PROPOSED RESIDENCE AT:

325 VIA LINDA

DAILEY JANSSEN ARCHITECTS

ROGER P. JANSSEN AR-14785
ARCOM # ARC-23-014
TC # ZON-23-029

A-1.01

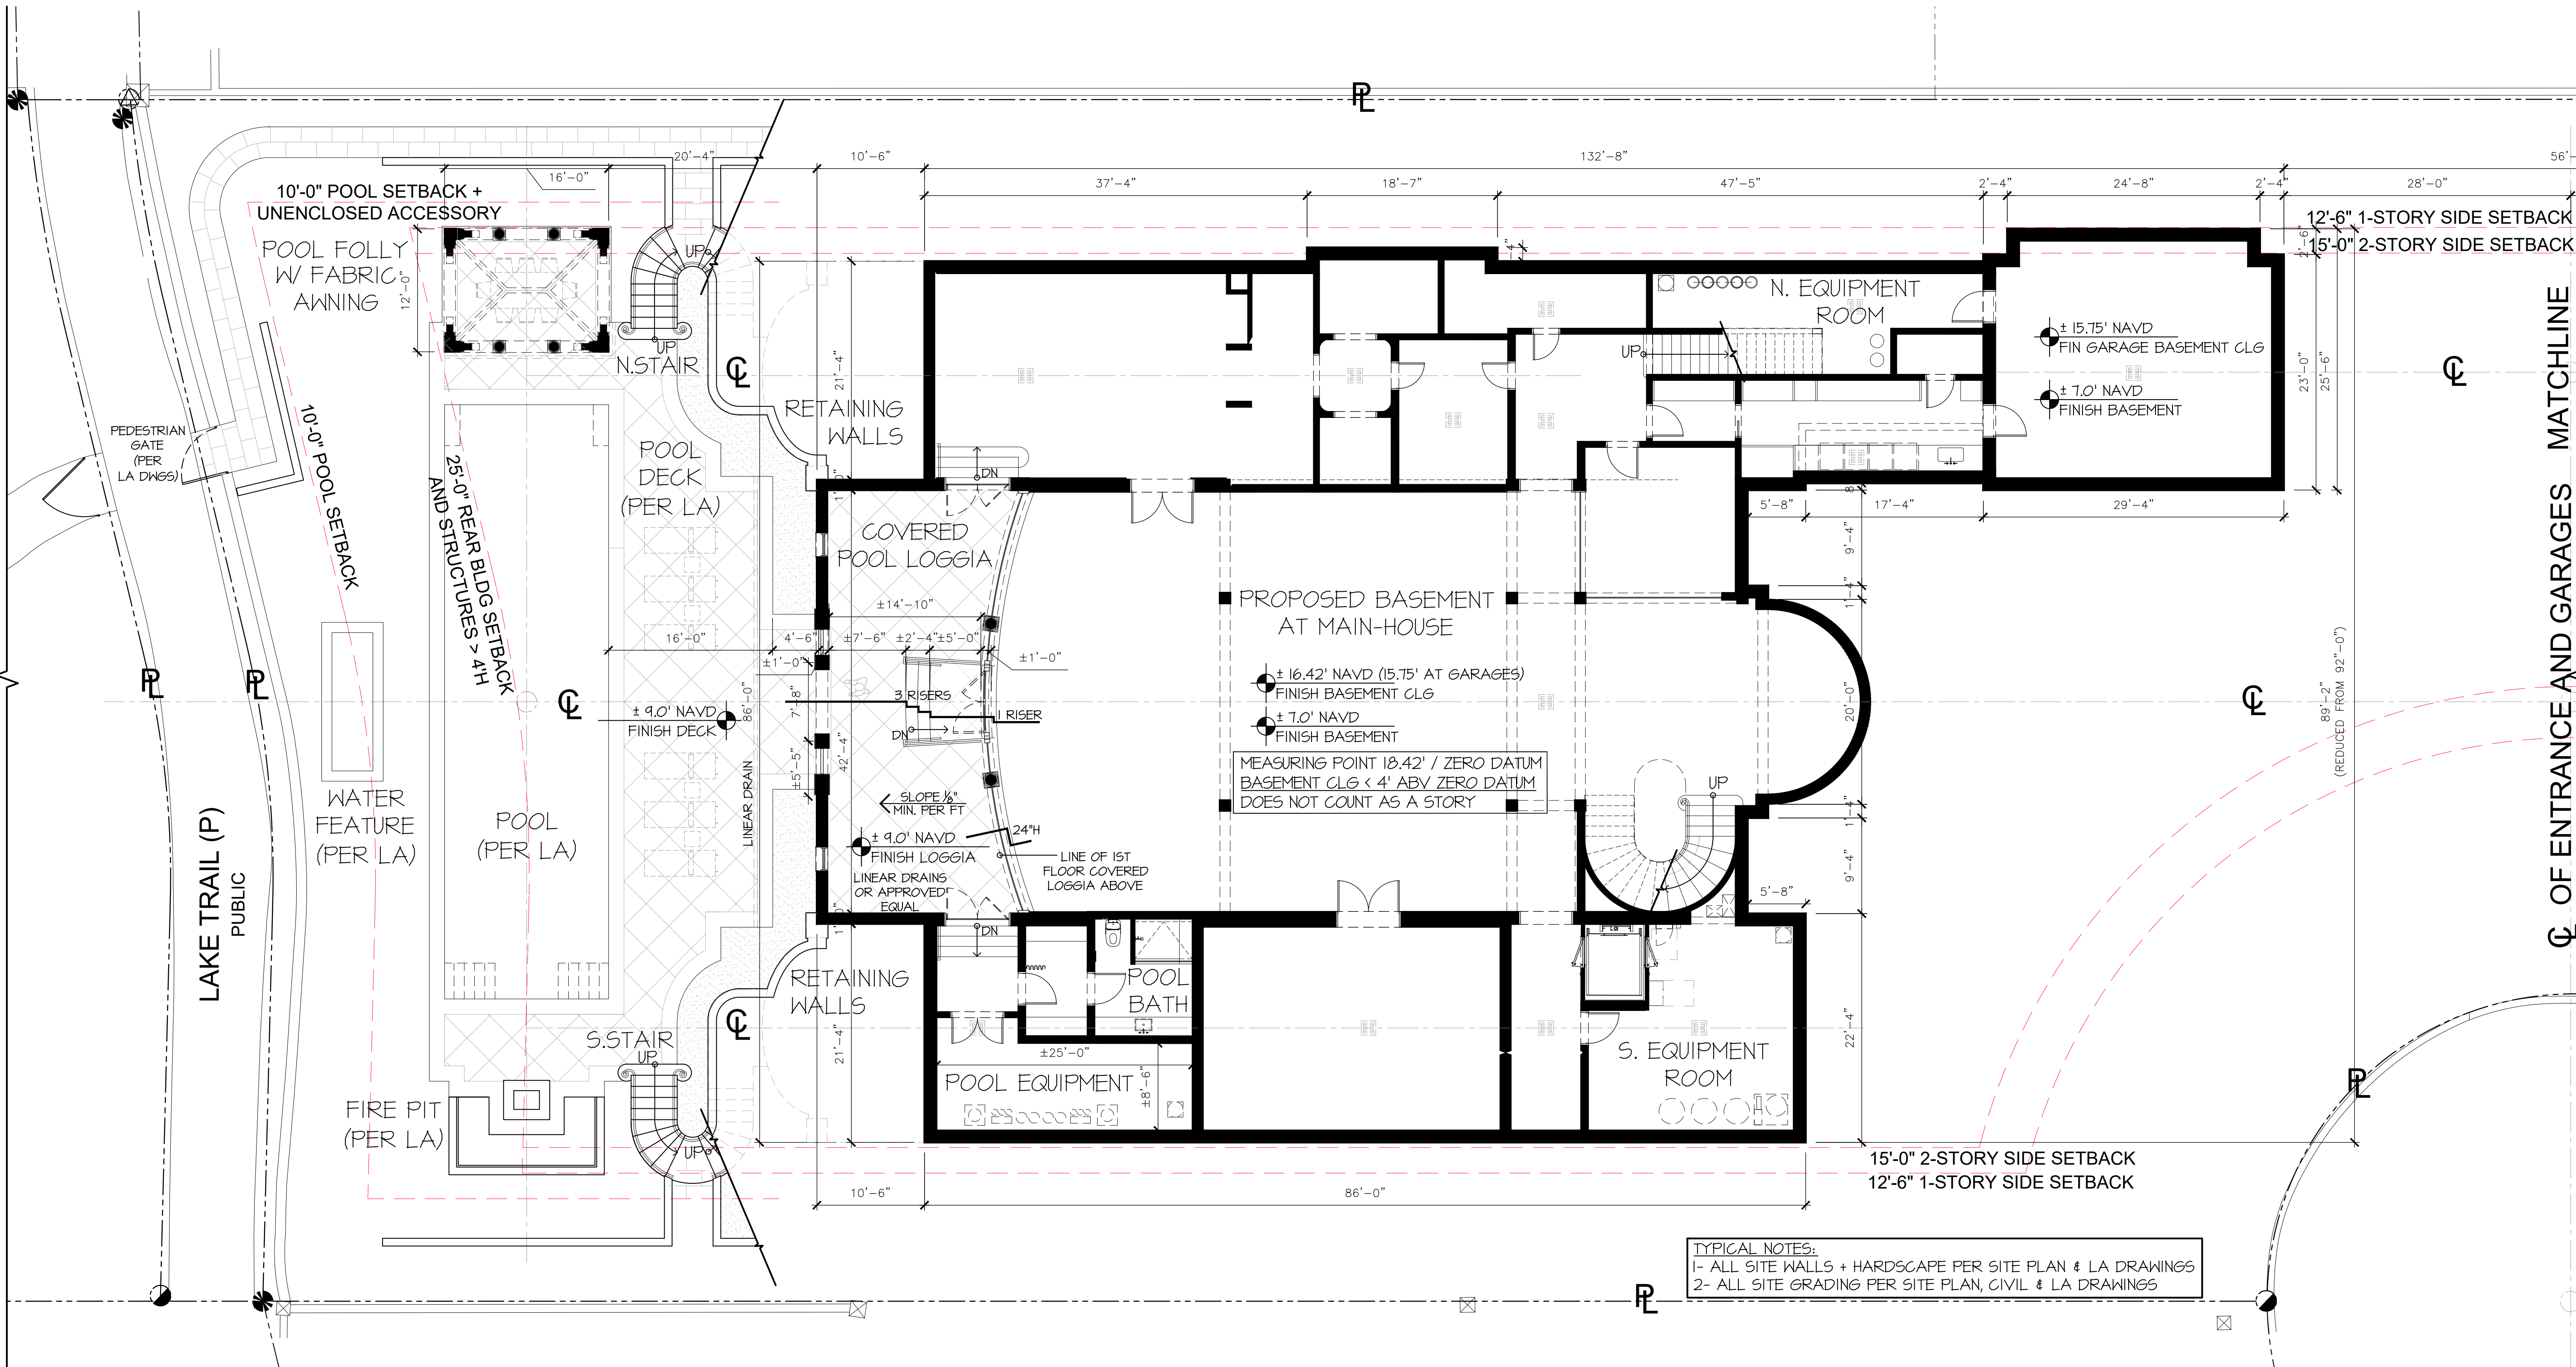
- REVISE BASEMENT LAYOUT TO REFLECT 1ST FLOOR REVISIONS (TO ALIGN WITH EXTERIORS WALLS ABOVE)
- SHIFT NORTH AND SOUTH REAR EXTERIOR STAIRS IN TO REVISED CENTERLINES OF REDUCED 1-STORY WINGS

A-1.02

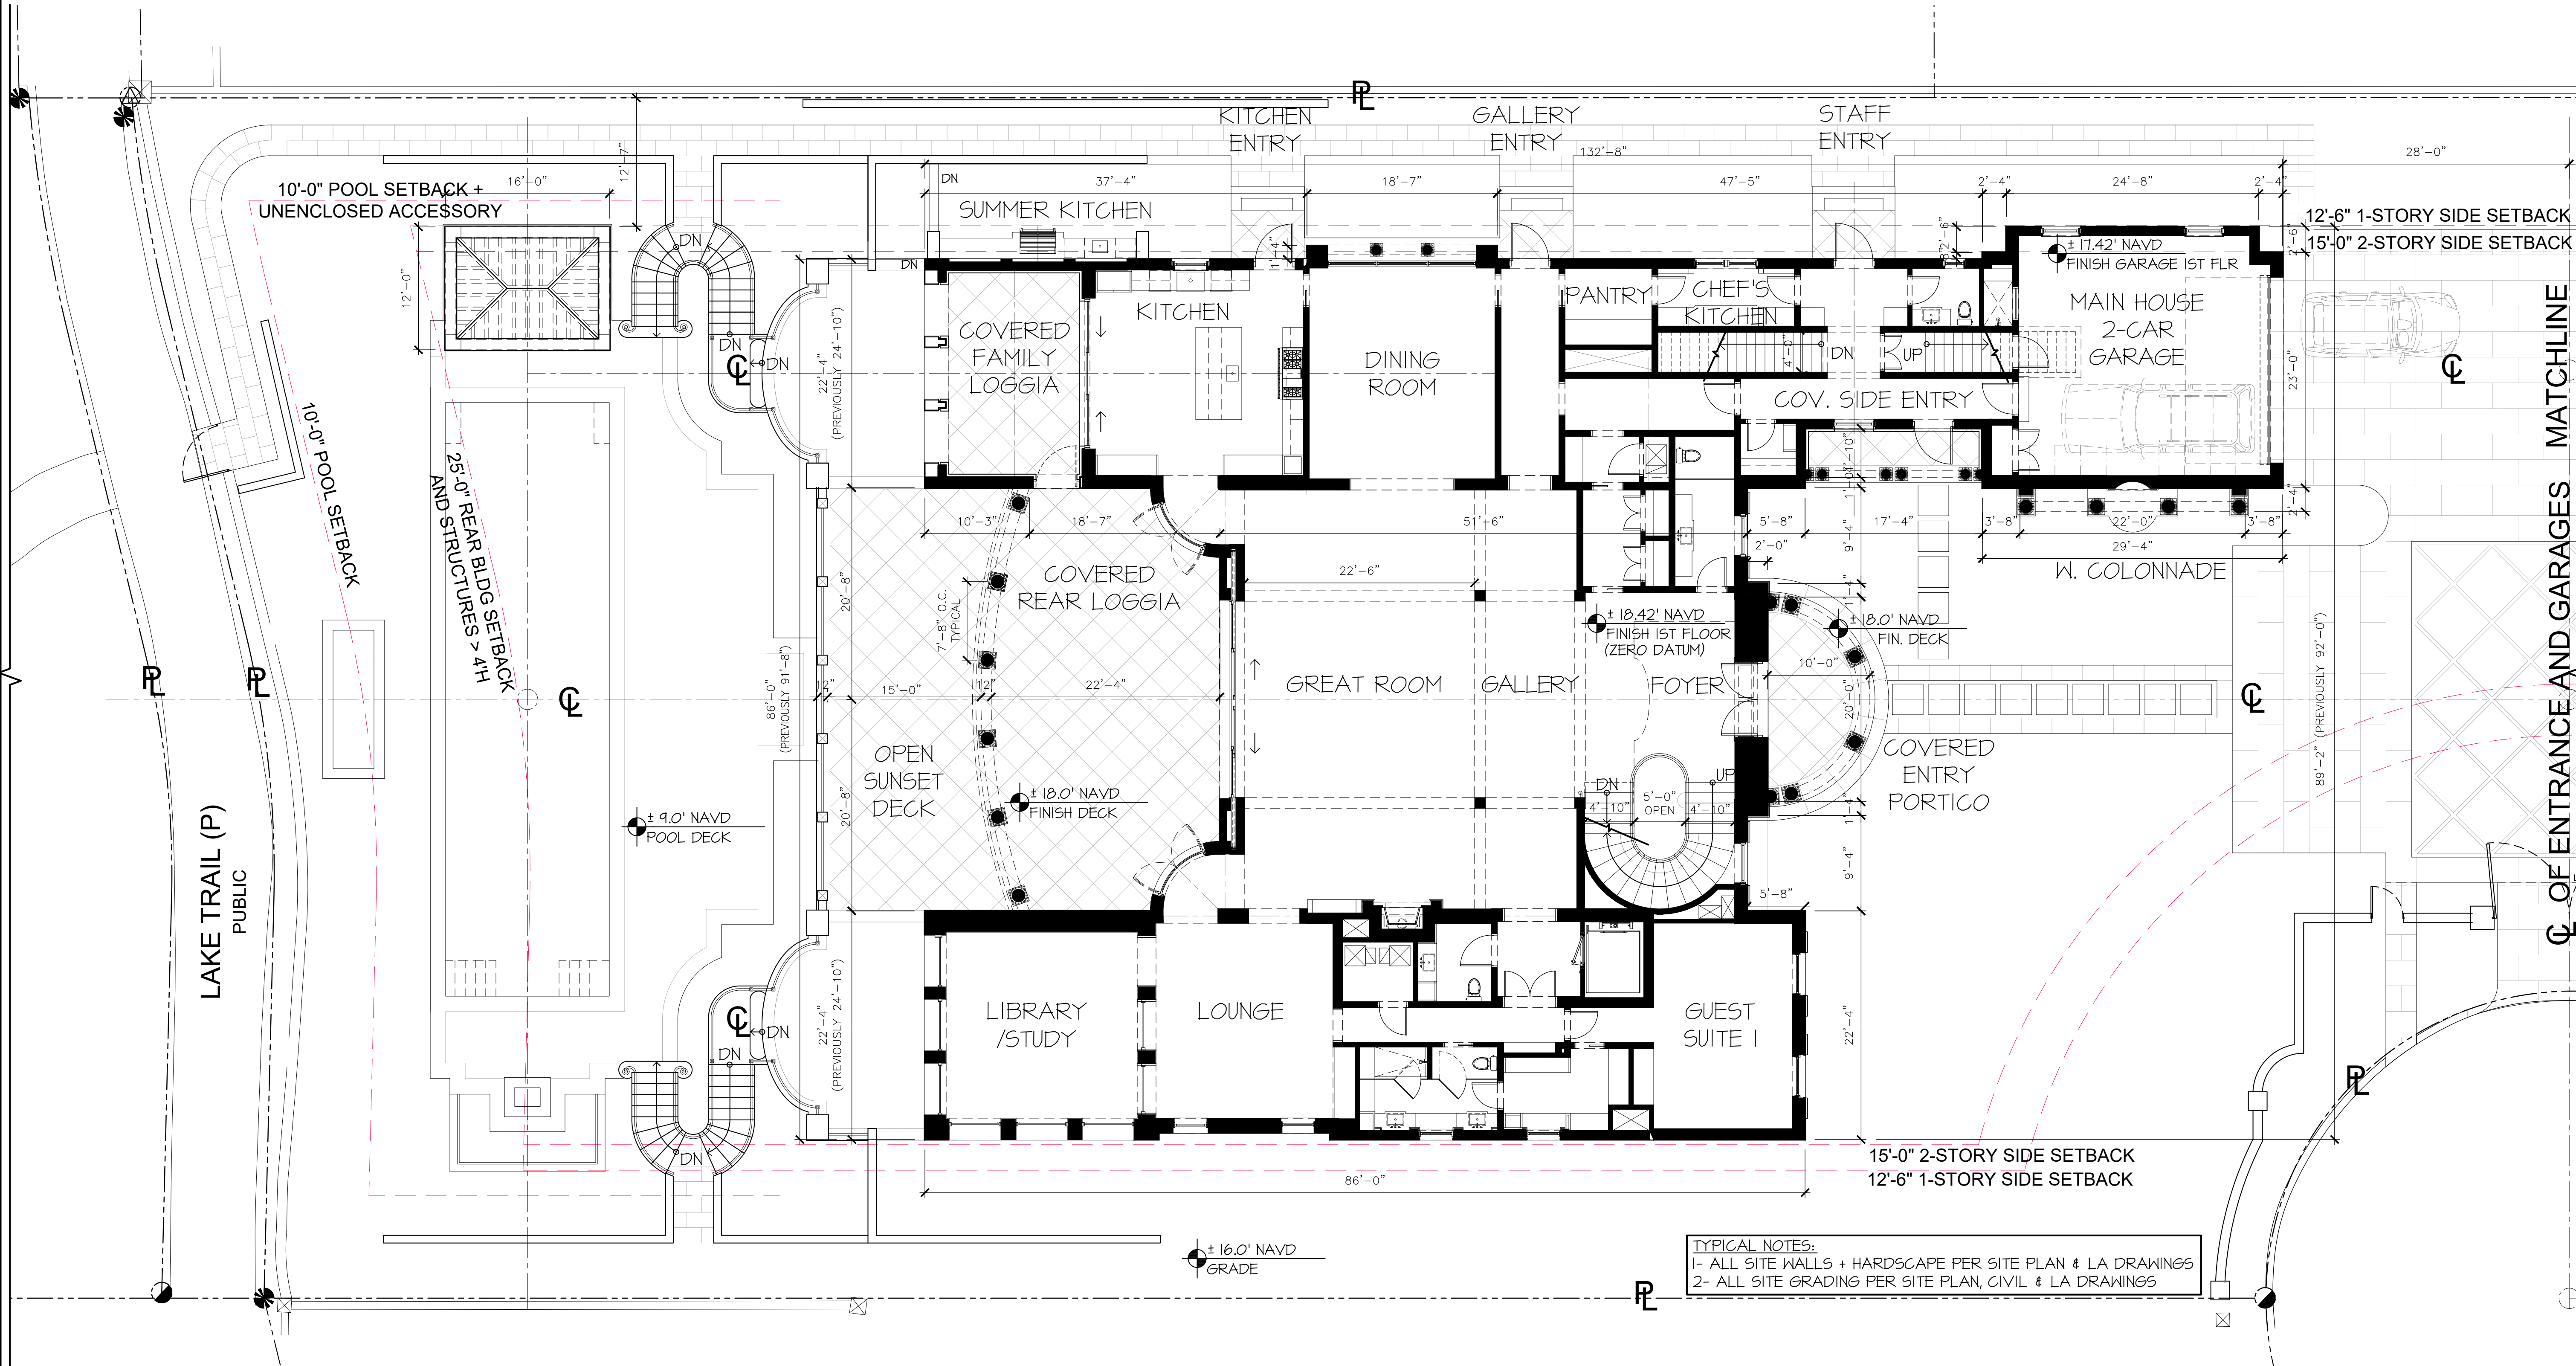
- REDUCTION OF I-STORY MASSING AT NORTH AND SOUTH REAR WINGS (24" MINIMUM) AND ELIMINATE I-STORY BAY AT THE EAST ENTRY ELEVATION (MAIN HOUSE) FOR A TOTAL OF 475 SF REDUCTION

A-1.02A

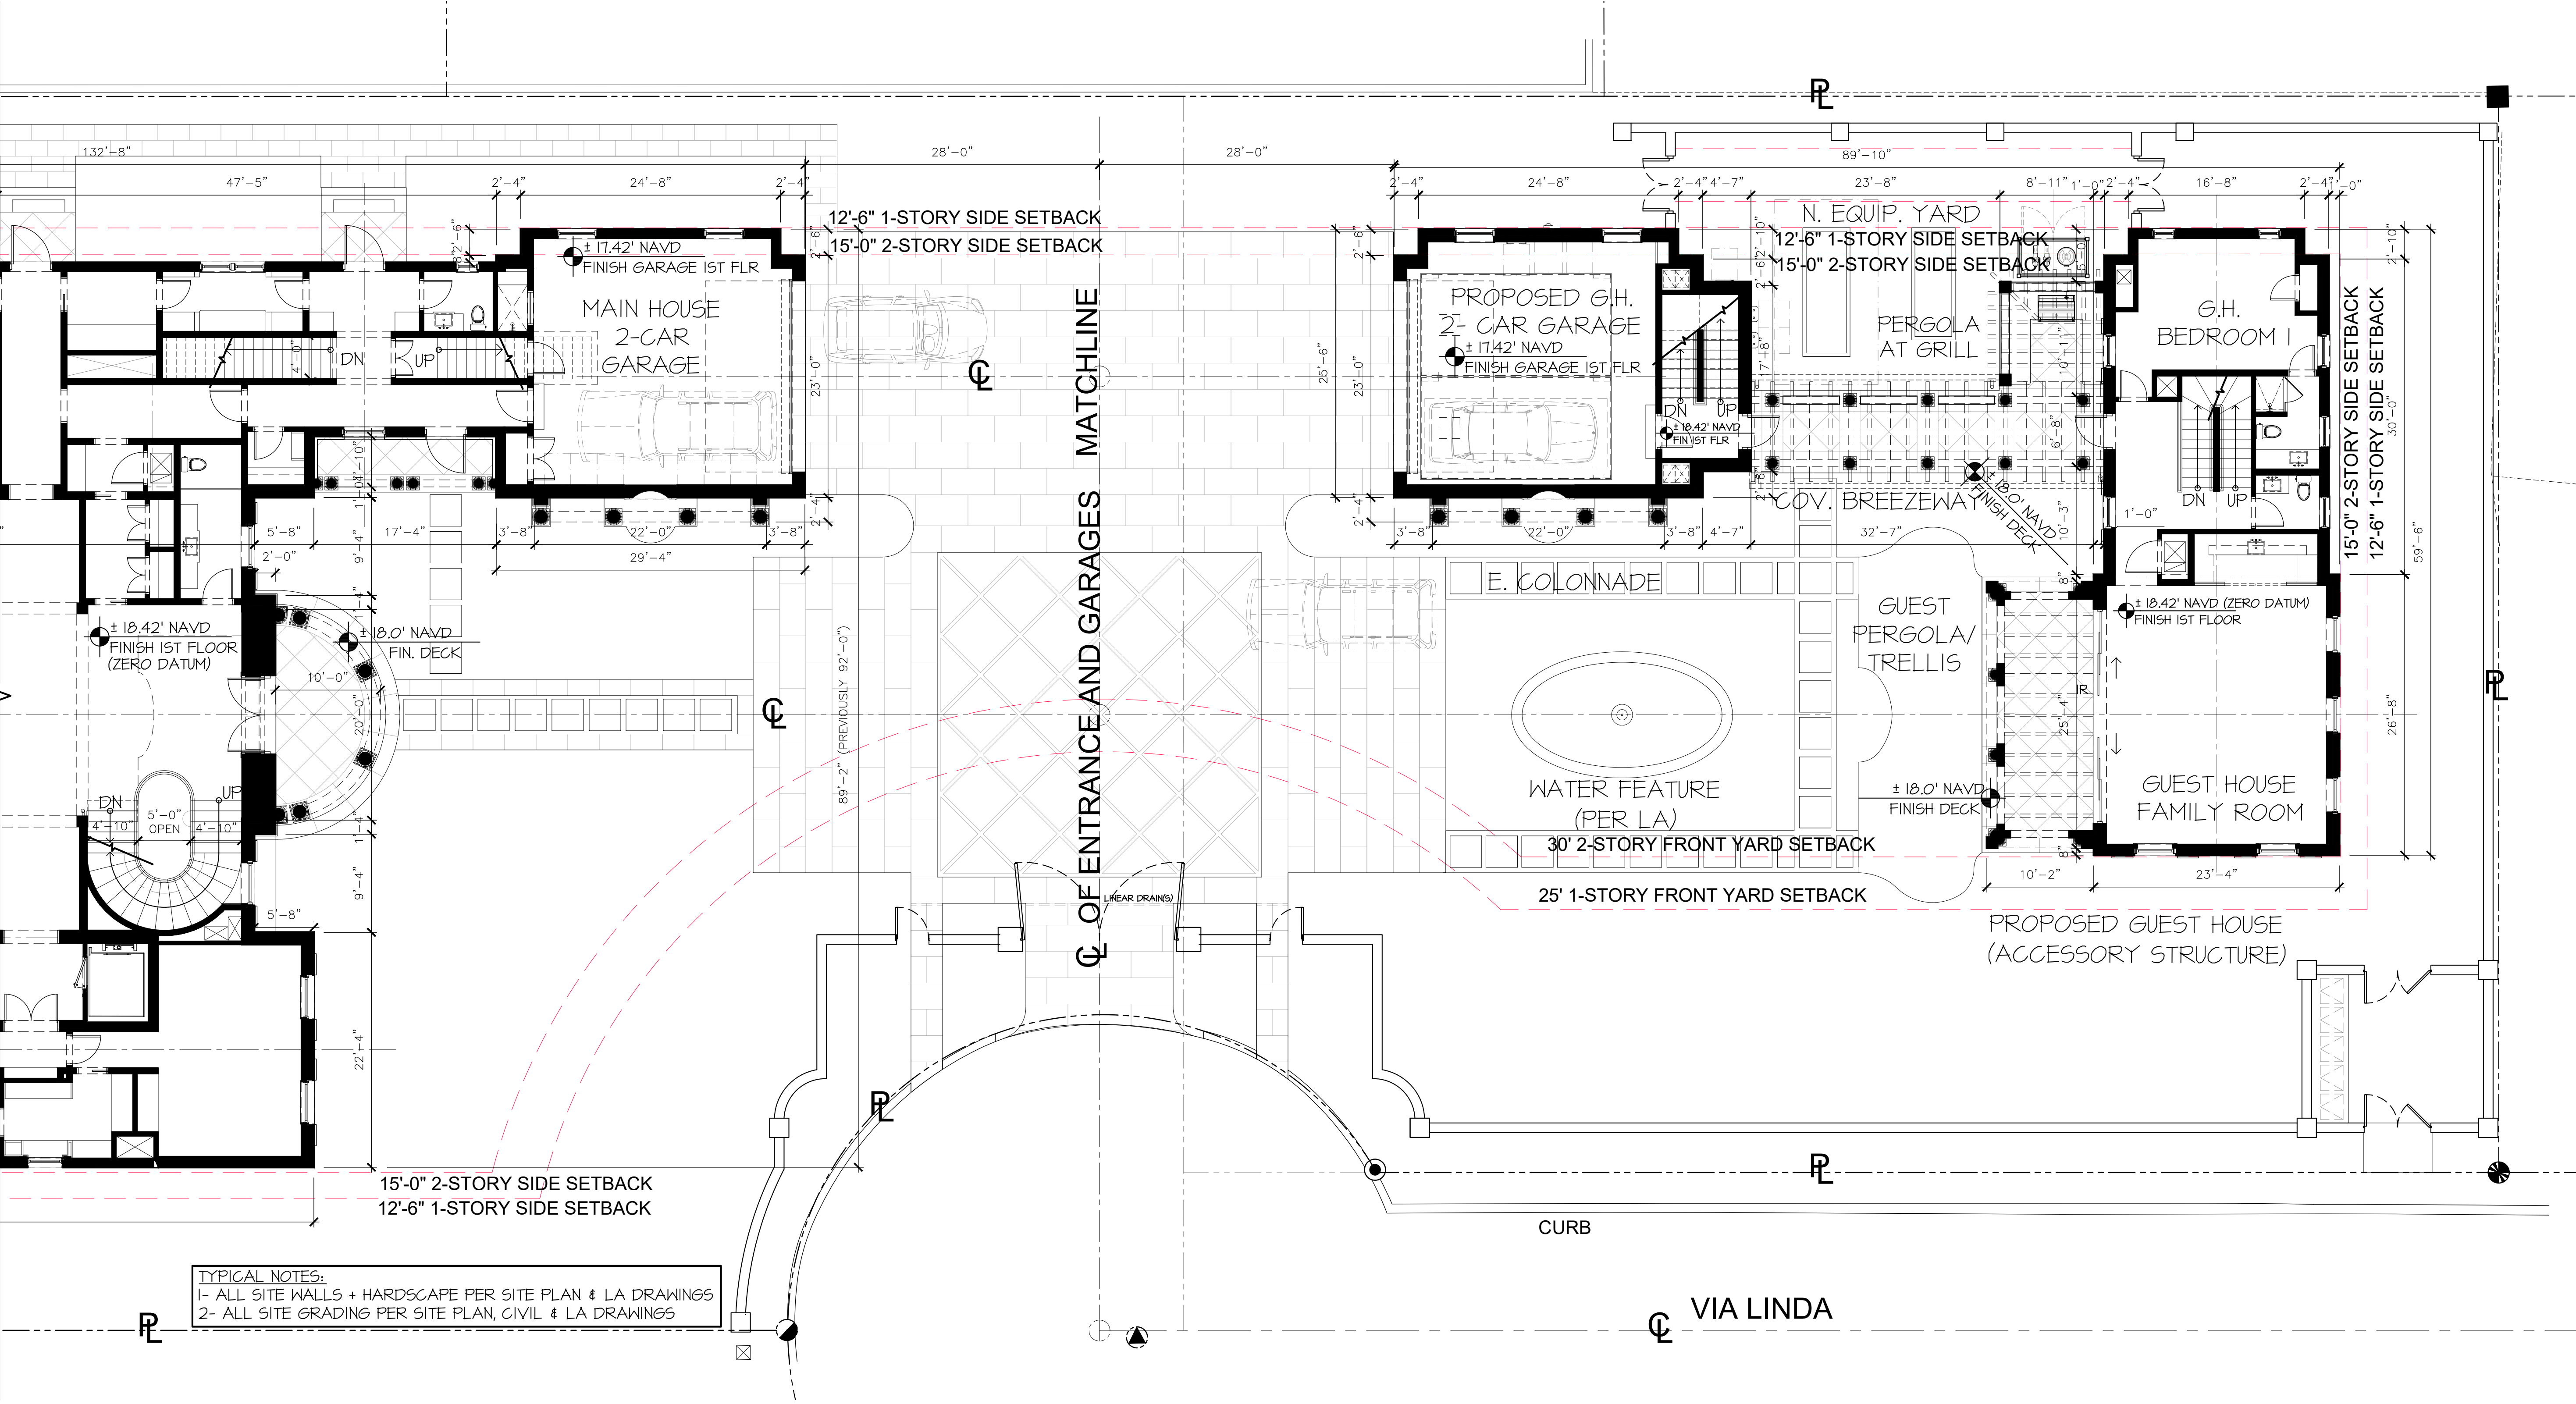
- REDUCTION OF 1-STORY MASSING AT NORTH AND SOUTH WINGS (REDUCE OVERALL WIDTH)
- ELIMINATE 1-STORY BAY AT THE EAST ENTRY ELEVATION (MAIN HOUSE)
- REVISE GUEST HOUSE PLANS, DUE TO ROOF REVISION
PROPOSED PARAPET WITH PITCHED ROOF IN LIEU OF MANSARD WITH DORMERS
